FINAL DRAINAGE REPORT
for
KINCH MINOR SUBDIVISION

December 6, 2021
Revised July 29, 2022

JPS Project No. 072101
PCD File No.: MS-224

Table 2 - Culvert Summary Table: Culvert C2

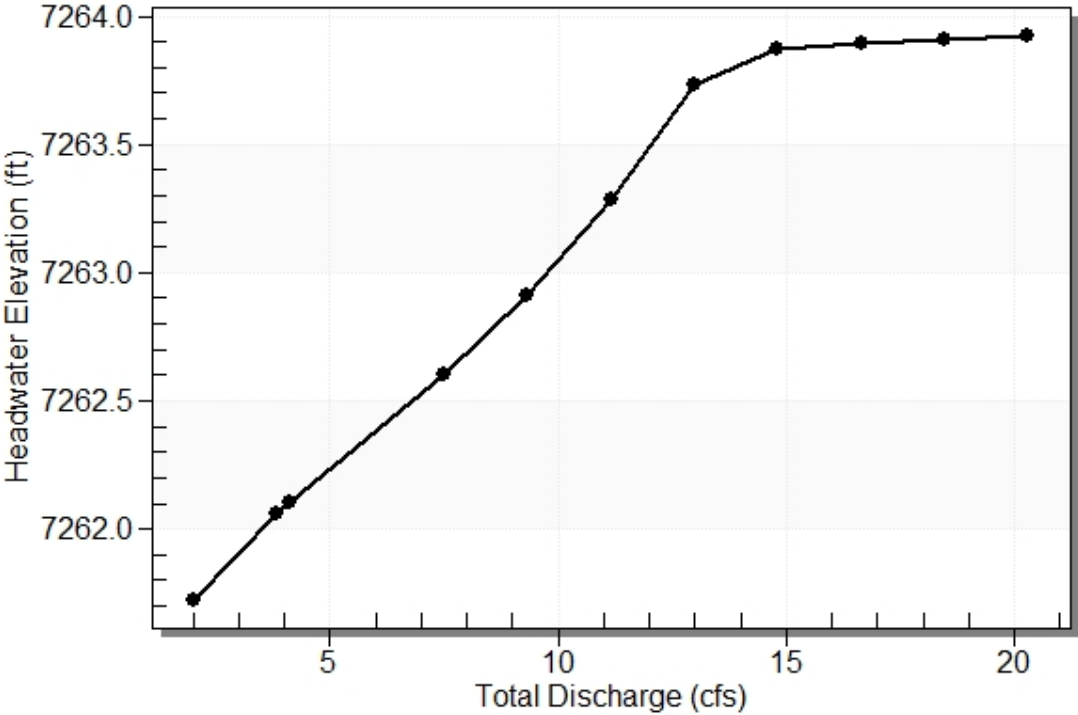
Per EPC DCM Table 6-5, HW/D should be 1.5 or less. It appears that for some flows it exceeds that amount. Increase proposed culvert size to meet criteria.

Roadway Data for Crossing: Crossing C2

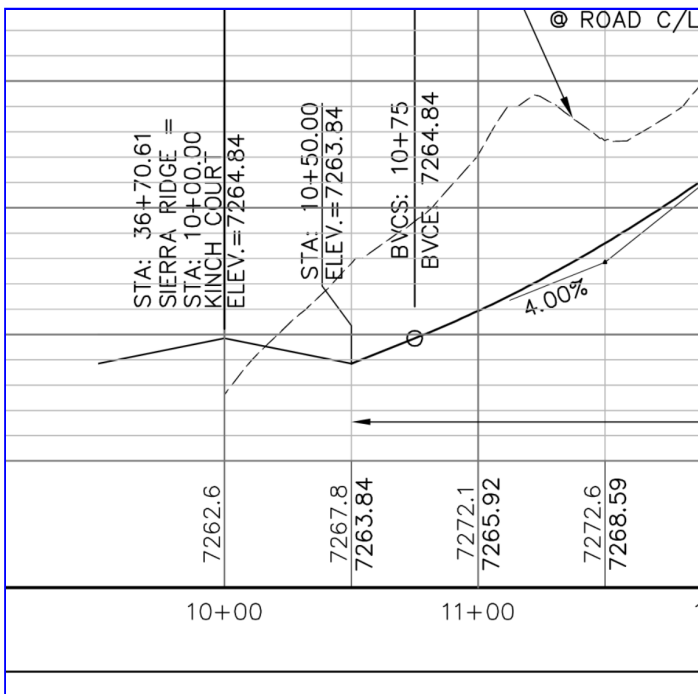
Crest length of road does not appear to be 100 feet long per profile. Double check to see confirm that is the case.

MAJOR BASIN / HISTORIC DRAINAGE PLAN

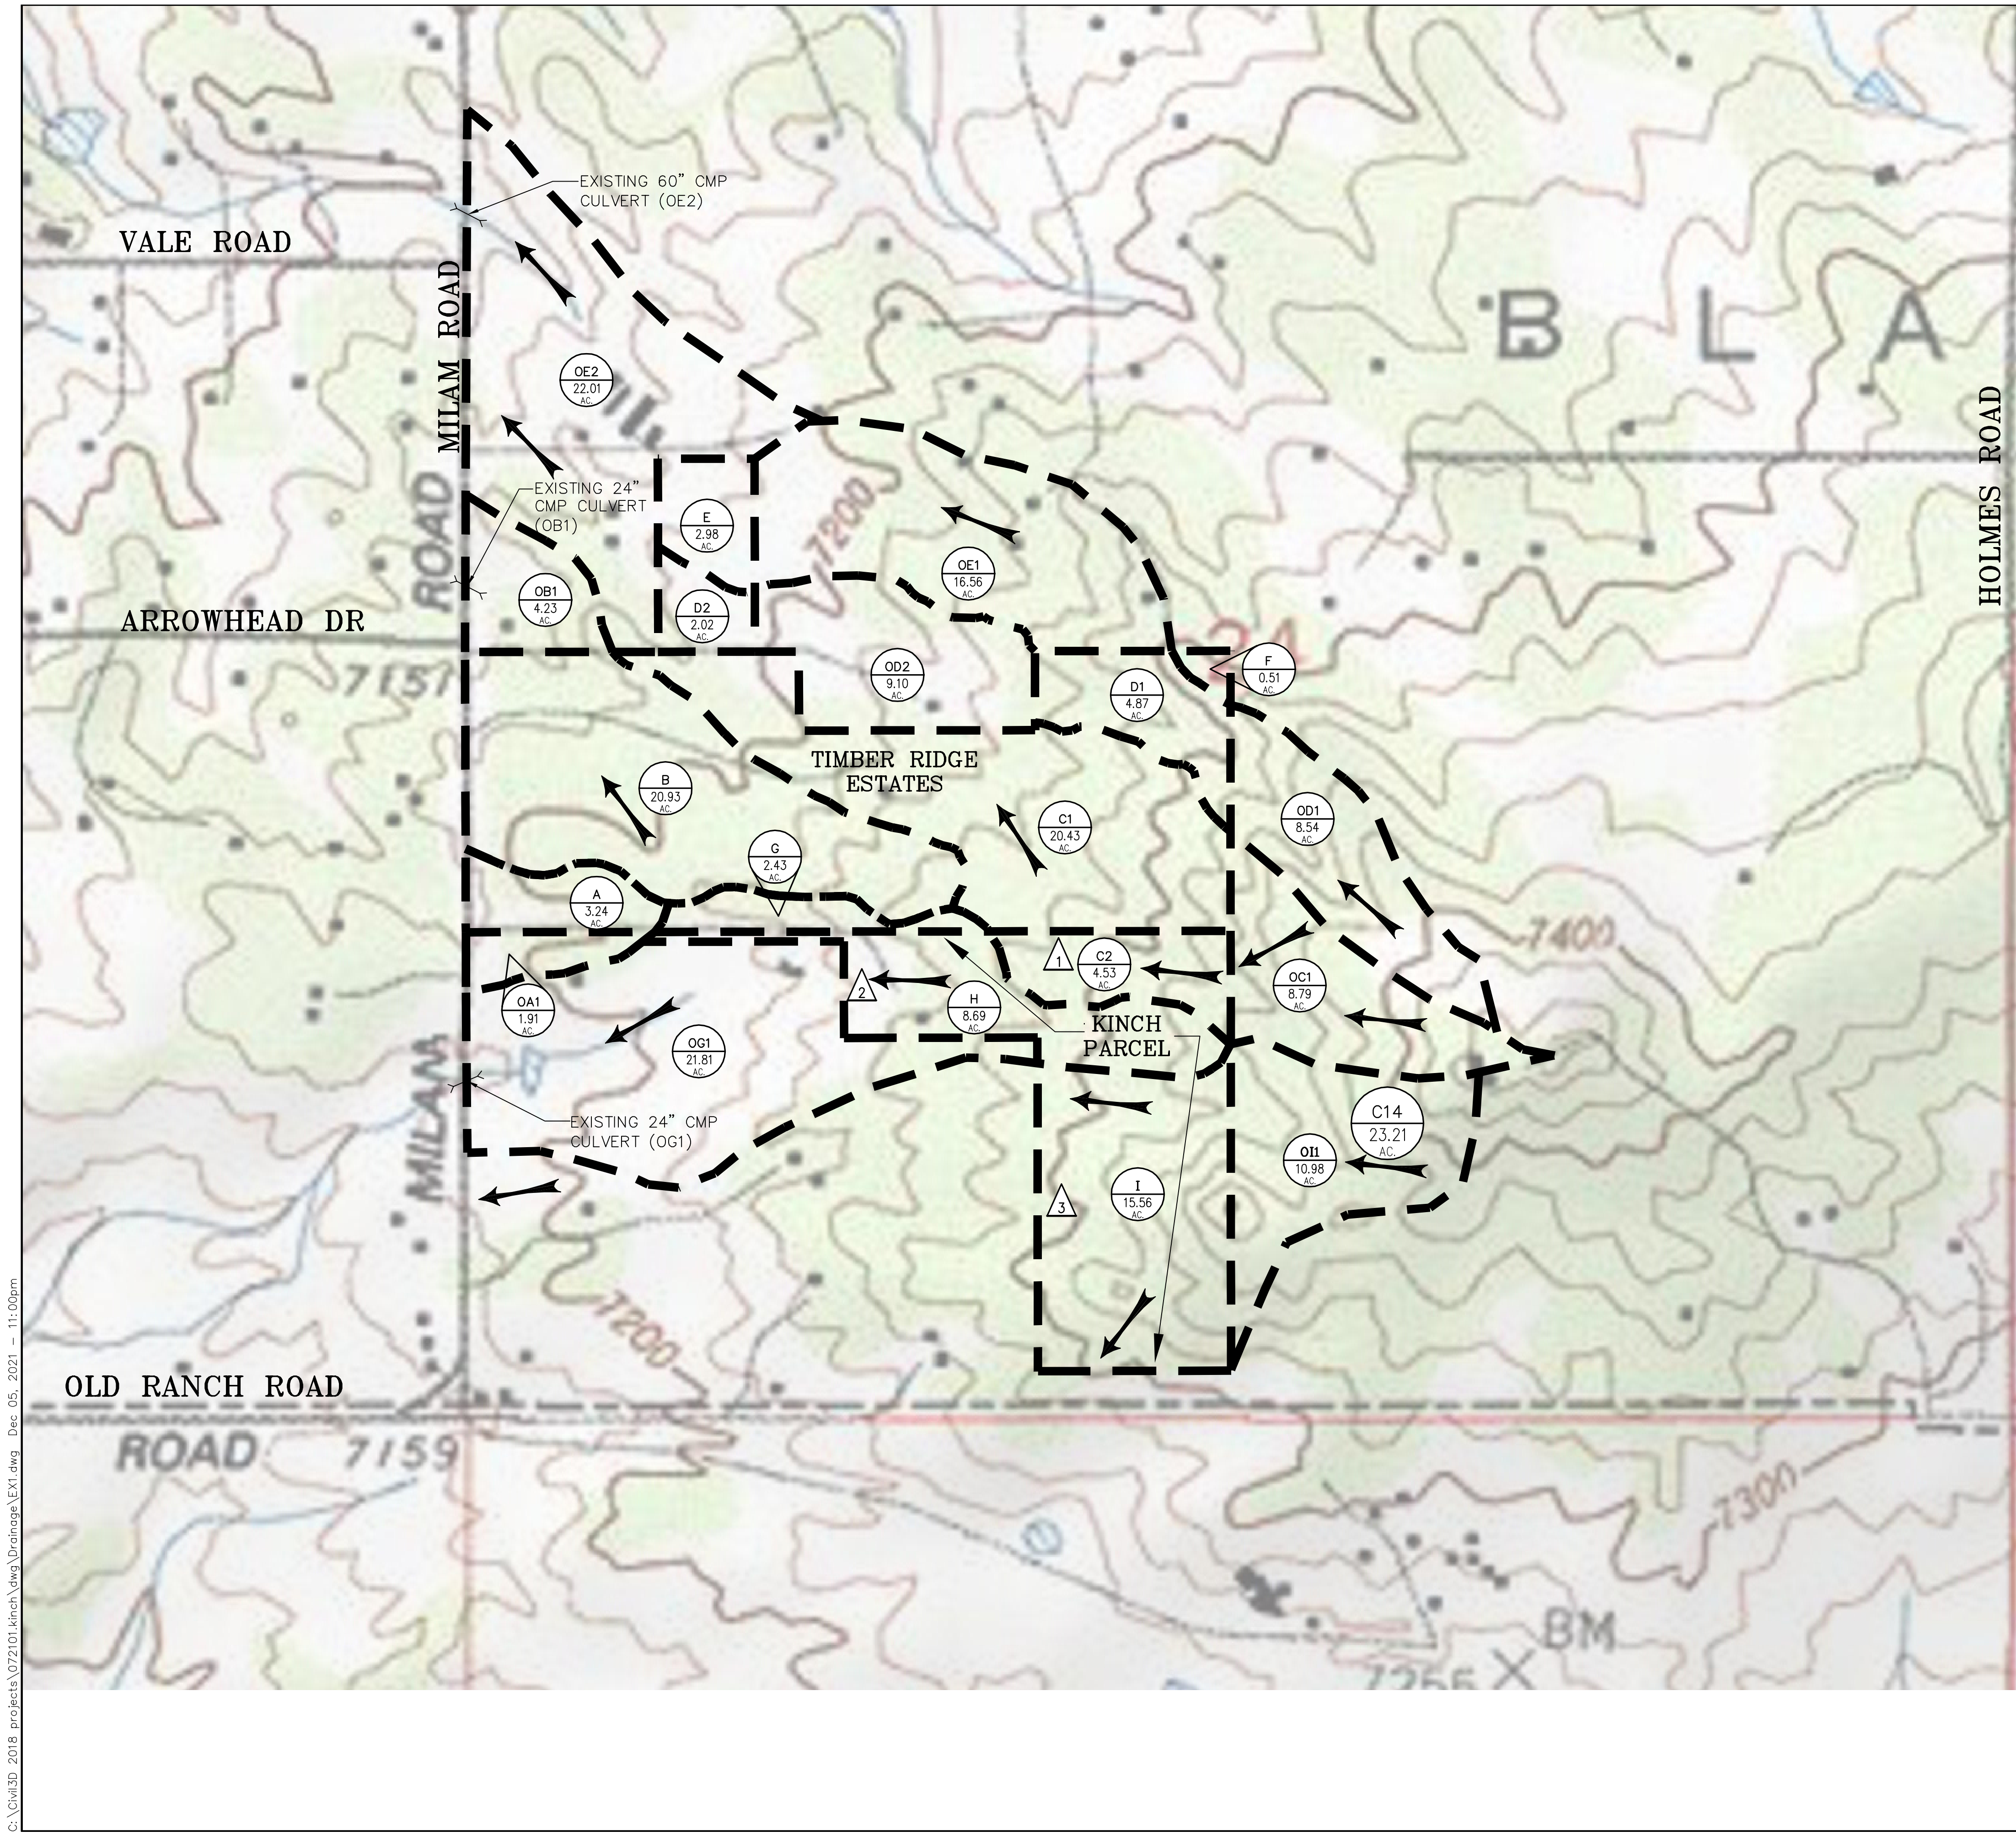
Unresolved. It appears that per the drainage map there are areas that will have more than 15 cfs crossing through the some areas. Per ECM 3.3.4.A. drainage easements are required where flow rates exceed 15 cfs. Please provide drainage easements where necessary.

DEVELOPED DRAINAGE PLAN

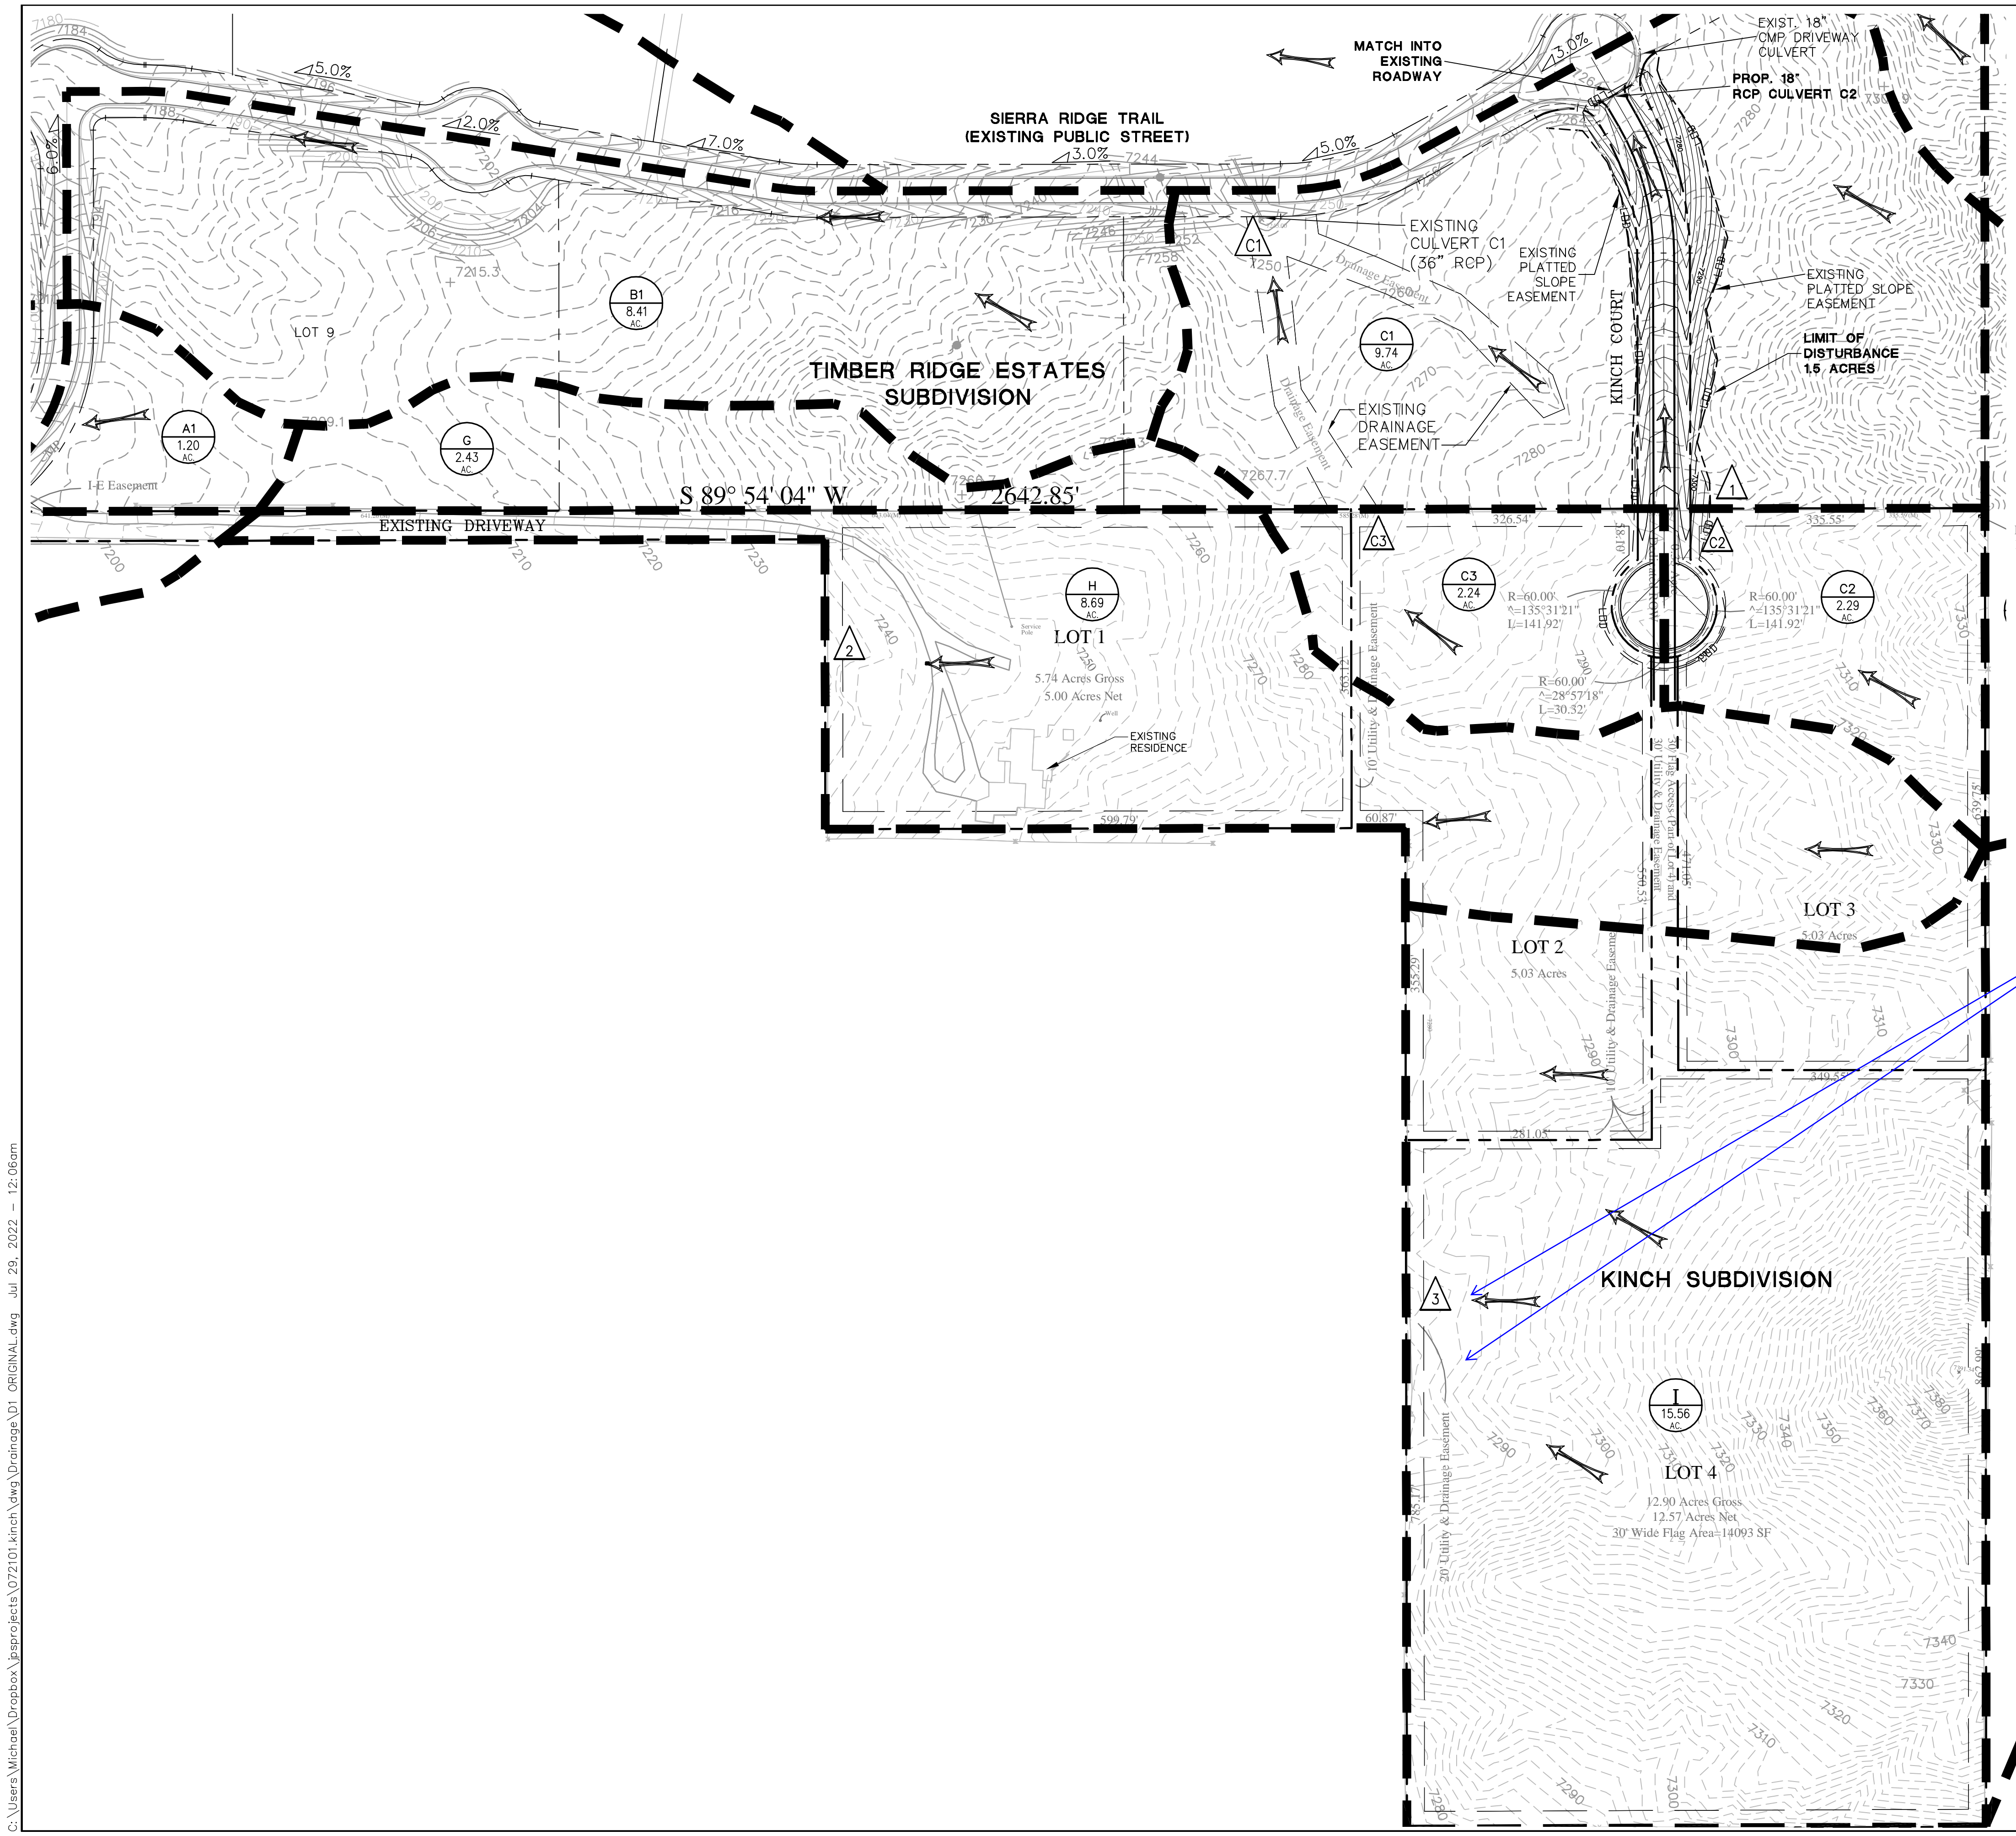
Per ECM 3.3.4.A, drainage easements are required where flow rates exceed 15 cfs. Please provide drainage easements where necessary. Extend drainage easements if necessary.
